SERVICE BULLETIN

SB039-1197

Subject: Lancair IV Fast Built, Gear Box Installation

Status: Mandatory Inspection/Installation

Fig. 1

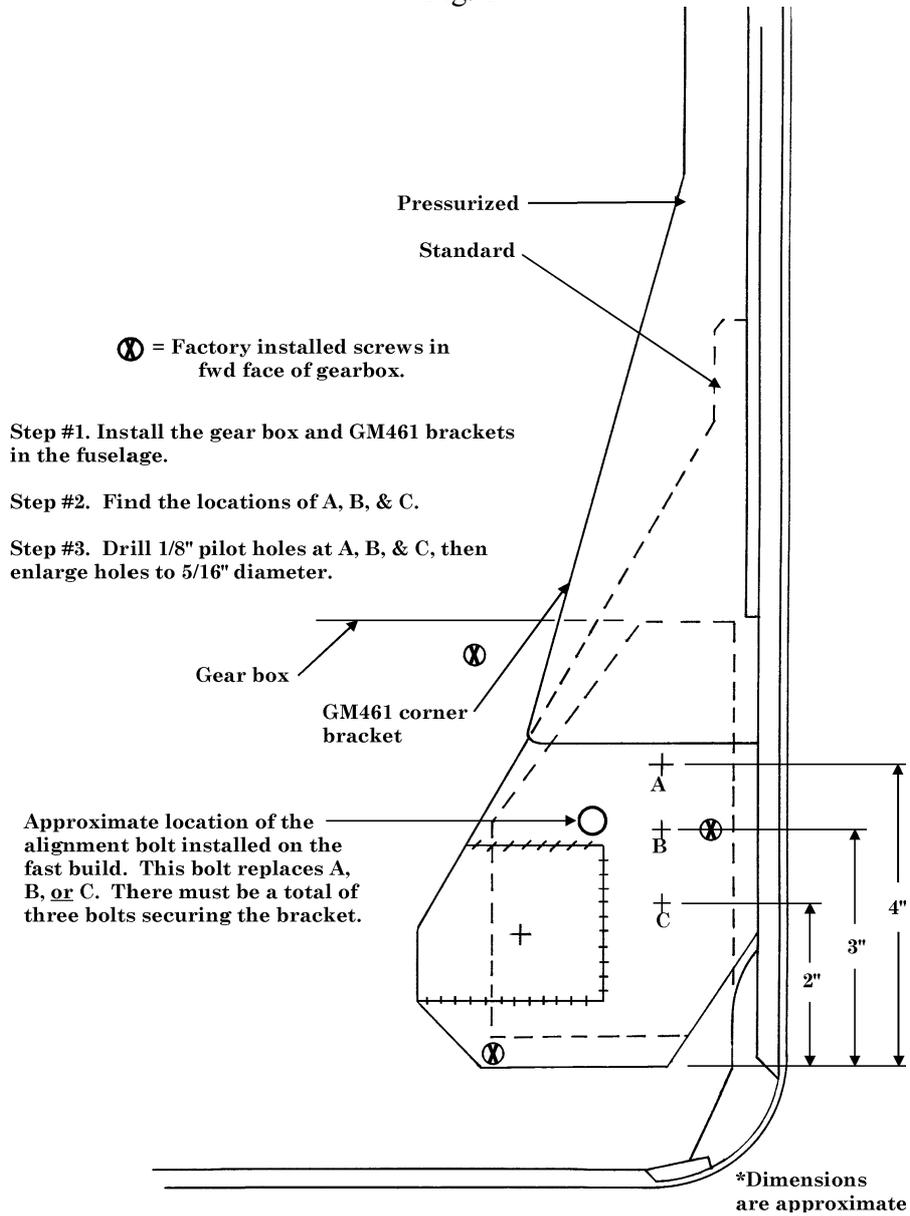
Most of the landing gear loads are transmitted into the fuselage through the GM461 brackets (installed on the forward face of gear box). In the Lancair construction manual, pages 19-57/58 shows bolts "A", "B", and "C", which are the load carrying bolts that secure the gear box to the side of the fuselage.

During the alignment process in building the fast build, we only install one of these bolts. The remaining two bolts must be installed by the builder. The one bolt installed on the fast build is not sufficient to carry the loads of the landing gear.

Verify that three AN5 bolts have been installed (including the bolt installed on the fast build). All bolts must go through the GM461 corner bracket, the forward face of the gear box, and the flange of the gear box.

- 1) Mark the location of the bolts in the Figure above.
- 2) Check that the locations clear the factory installed screws in the forward face of the gear box. Check that the holes would go through both the flange of the side of the gear box and the front of the gear box (Refer to above figure). If you have difficulty installing the bolts at these locations refer to the Alternate Installation Locations of Figure 3.

Fig. 2

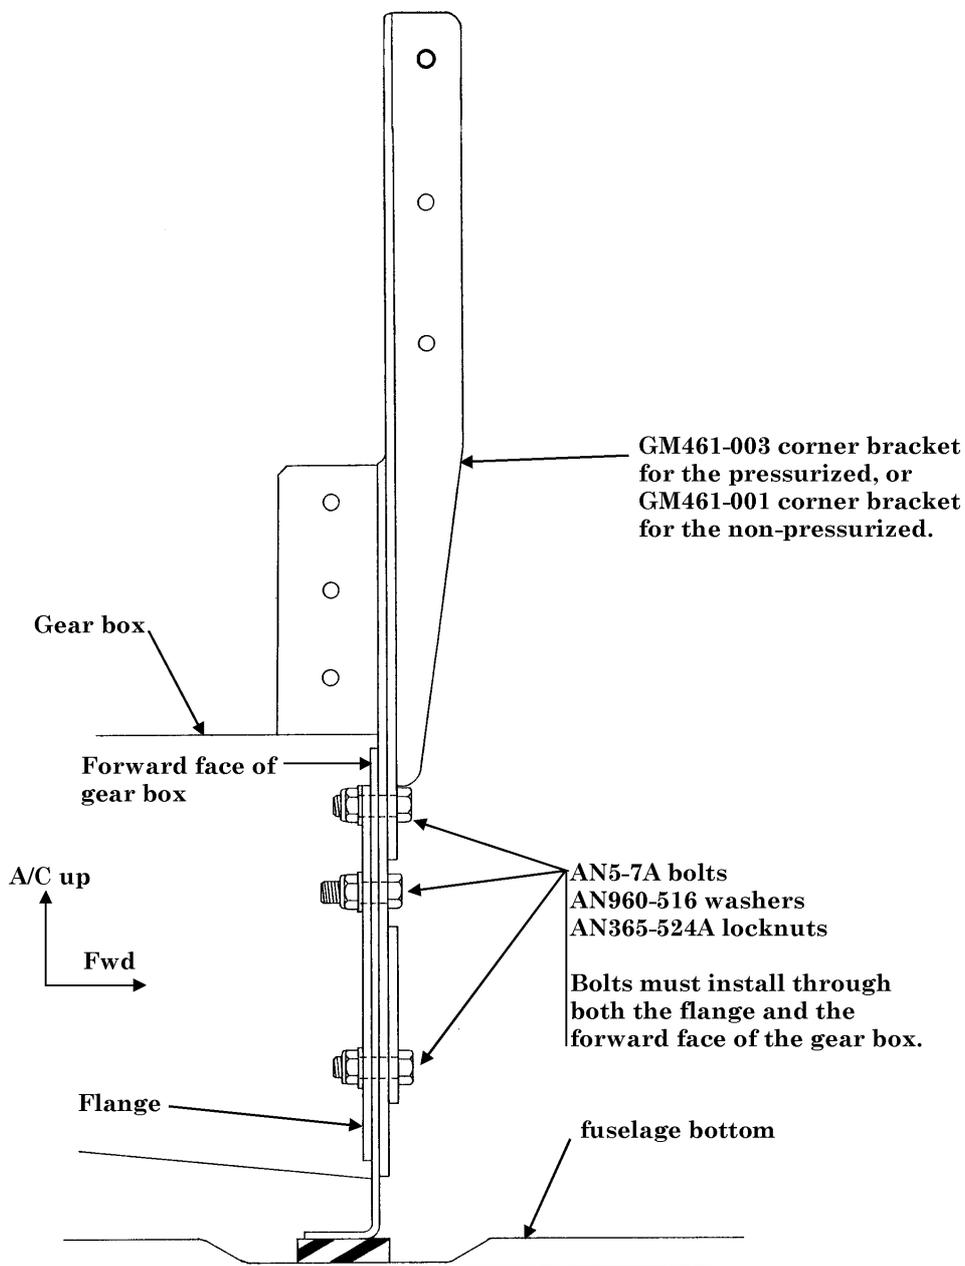
You may have difficulty installing the bolts at locations "A" and "C" as these locations are close to the corner of the gear box. In the procedure below there is an alternate location for the bolts should you have this clearance problem.
